TECHNICAL BULLETIN

* Supersedes Technical Bulletin TB600-007R1, dated 13 April 2006. Revised to correct tooling part numbers and re-sequence assembly steps. Aircraft that are in compliance with TB600-007R1 meet the intent of this revision.

FUSELAGE AFT SECTION AND TAILBOOM MODIFICATION

Model 600N Helicopters, serial number RN003 thru RN066 and RN068.

Figure 5. Tailboom Assembly Rework

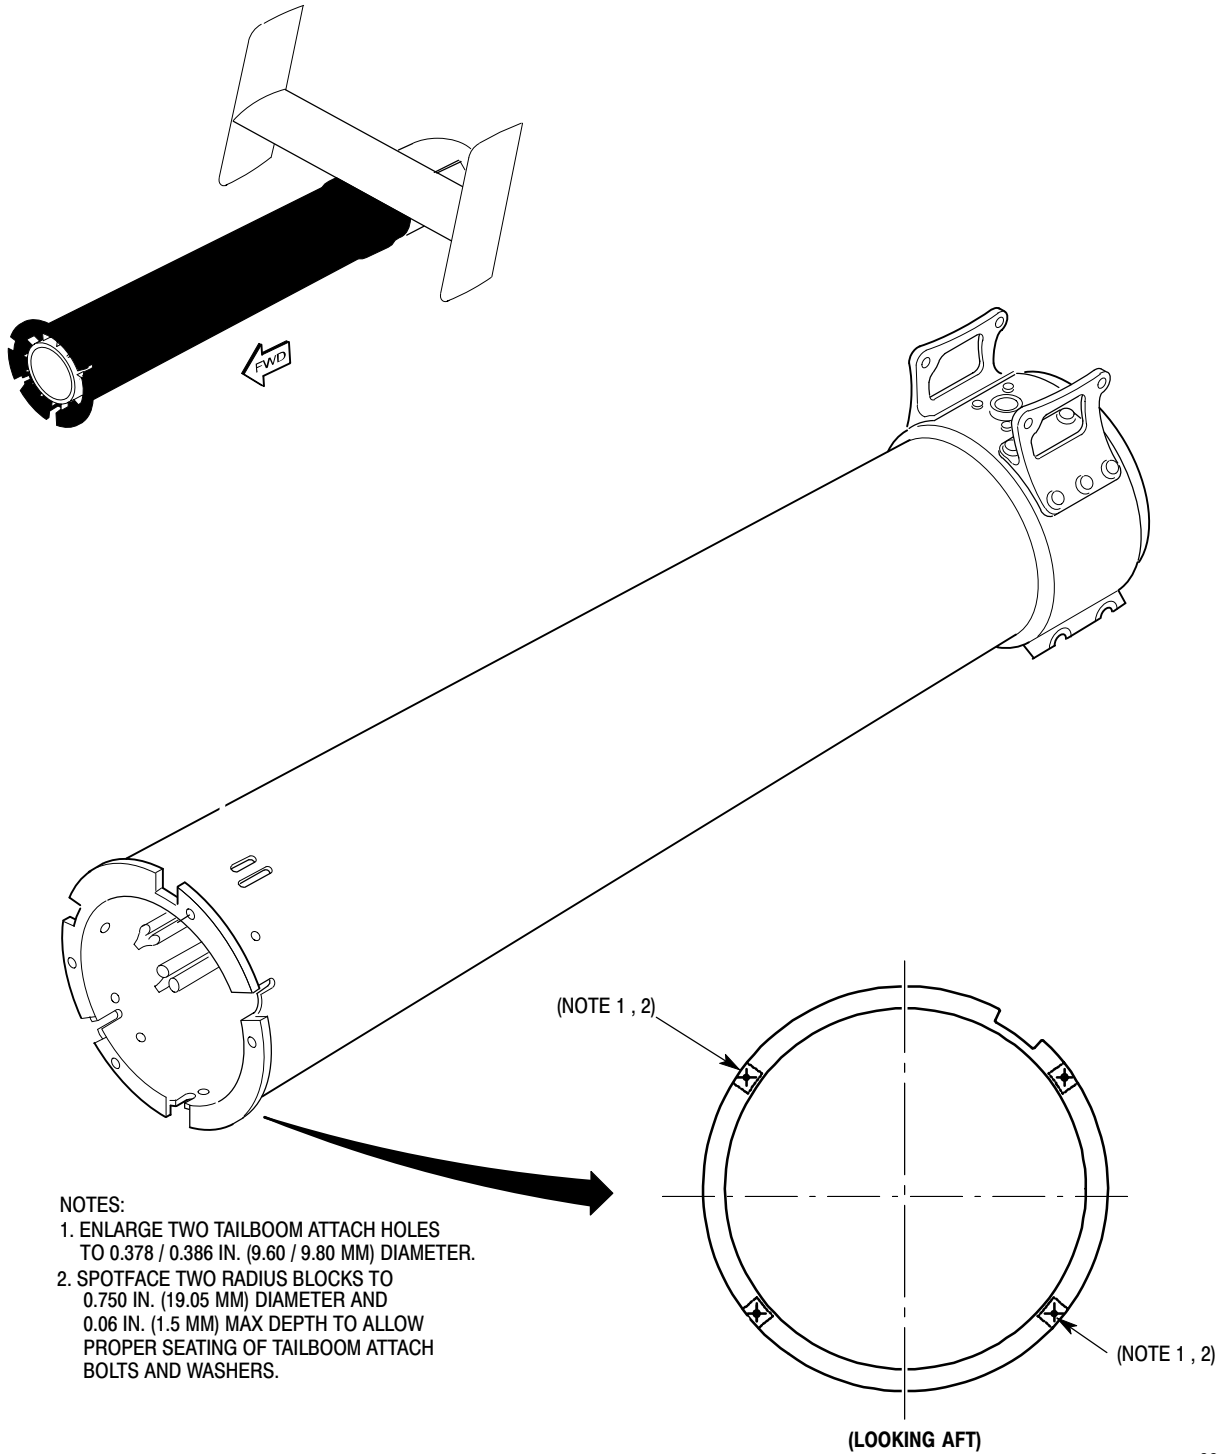
NOTE: After completing the modification procedure below, the tailboom assembly cannot be installed on any helicopter serial RN003 thru RN068 that has not been modified by this Bulletin.

- (a). Using drill fixture 600N3510-1-DJ1, ream two tailboom attach holes to 0.378/0.386 inch (9.60/9.80 mm) and spotface to 0.750 inch (19.05 mm) diameter and 0.06 inch (1.5 mm) maximum depth.
- (b). Apply chemical coating to reworked holes in radius blocks per manufacturer's instructions.
- (c). Reidentify modified tailboom assembly. Pre and post modification part numbers are shown in Table 1).
 - 1). Carefully remove ID plate from tailboom assembly.
 - 2). Clean area where new ID plate will be installed with isopropyl alcohol or acetone.
 - 3). Peel backing off new ID plate and press plate on prepared surface. Roll ID plate with 1 inch (25.4 mm) cylindrical plastic roller.
 - 4). Edge seal ID plate with clear epoxy.

1. ENLARGE TWO TAILBOOM ATTACH HOLES TO 0.378 / 0.386 IN. (9.60 / 9.80 MM) DIAMETER.
2. SPOTFACE TWO RADIUS BLOCKS TO 0.750 IN. (19.05 MM) DIAMETER AND 0.06 IN. (1.5 MM) MAX DEPTH TO ALLOW PROPER SEATING OF TAILBOOM ATTACH BOLTS AND WASHERS.
